# WEATHERFORD HALL

## ADA ASSESSMENT & SURVEY

OREGON STATE UNIVERSITY (OSU)

Re: ADA Accessibility Survey and Assessment – Weatherford Hall

| Field Date: | 4/4/2014 | Report Date | 9/30/2014 | Barrier #: | 3B |

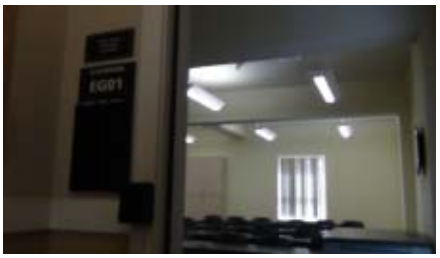
| Notes: | Storage room door EG02 included. Also, braille not 3/8" and max. 1/2" directly below the tactile characters |

| Rec. Solution: | Provide accessible signs and mount at proper height |

Barrier Type: Coat Hook - Height

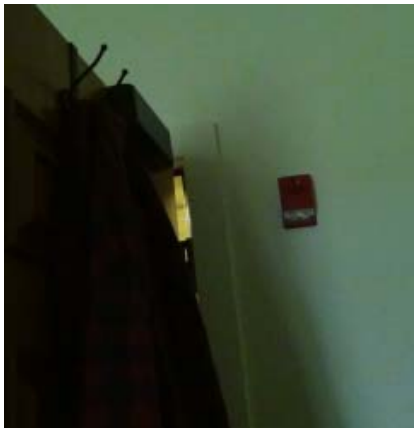
Barrier Description: Clothing hooks not max. 48" high AFF

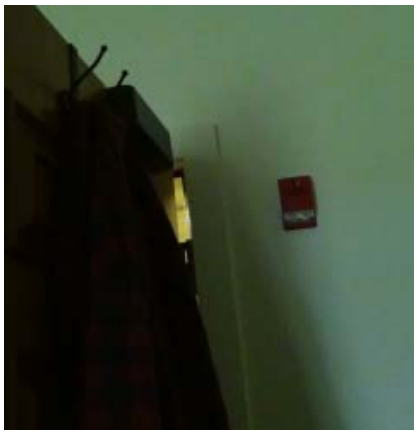
Barrier Description: Strobe not mounted at 80" AFF or 96" high, whichever is lower

Findings: 77" high

Barrier Type: Desk - Clear Floor Space

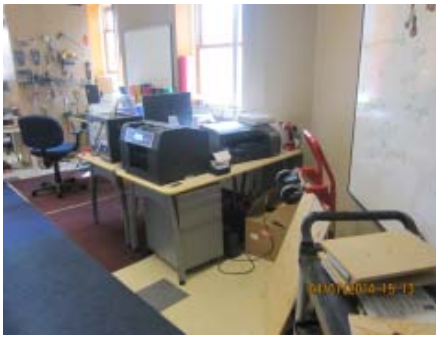
Barrier Description: Clear floor space 30" x 48" not provided at desk

Barrier Type: Carpet/Rug

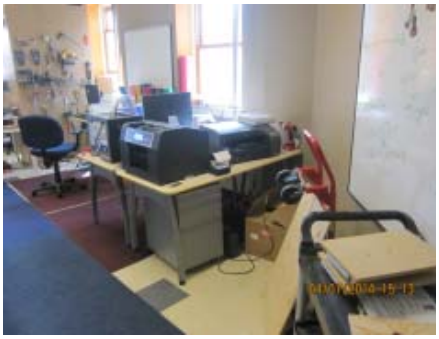
Barrier Description: Carpet/rug not anchored to floor (possible trip hazard)

Barrier Type: Horn/Strobe - Staff Area

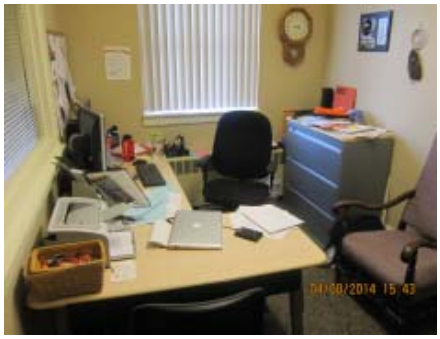
Barrier Description: No horn/strobe in staff areas

Barrier Type: Strobe Height - 80" on Wall

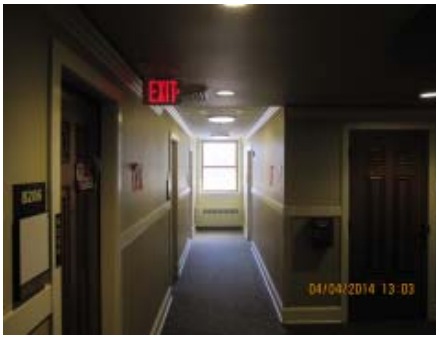
Barrier Description: Strobe not mounted at 80" AFF or 96" high, whichever is lower

Barrier Type: Landing - Existing (2.1% to 3.0%)

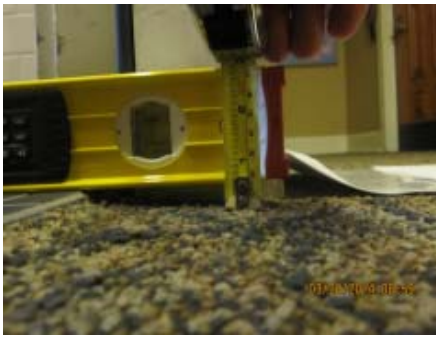
Barrier Description: Door or gate lacks landing on both sides of door

Barrier Type: Threshold - Height exceeding 1/4" without bevel

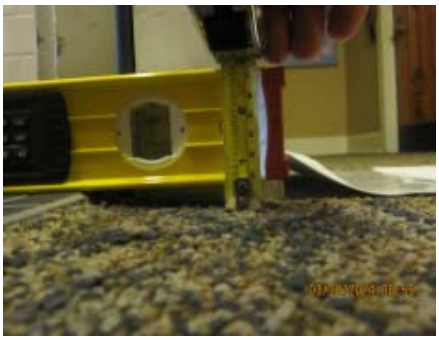
Barrier Description: Door/Gate threshold exceeds 1/4" in height without a bevel
